# HARTING Product Change Notification

**PCN/17/026/PM+MD**

**Product range:** DC2 / Circular connectors

**Title:** M12 Slim Design shielding element improvement - External

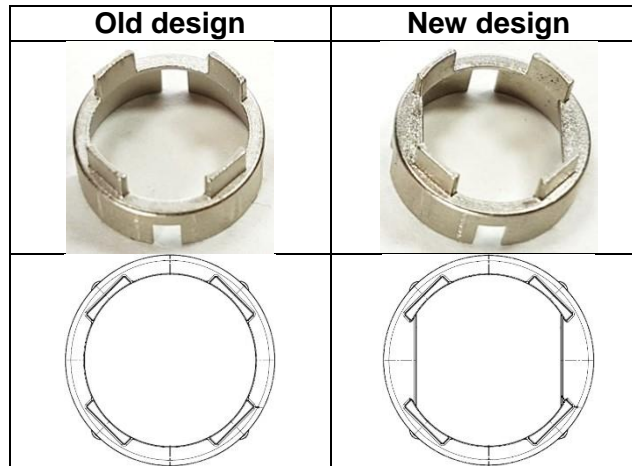
The inner contour of the shielding element of M12 Slim Design straight connectors has been changed from round shape to double D shape. This improvement secures the proper assembly and avoids the displacement of the contact carrier in assembled condition.
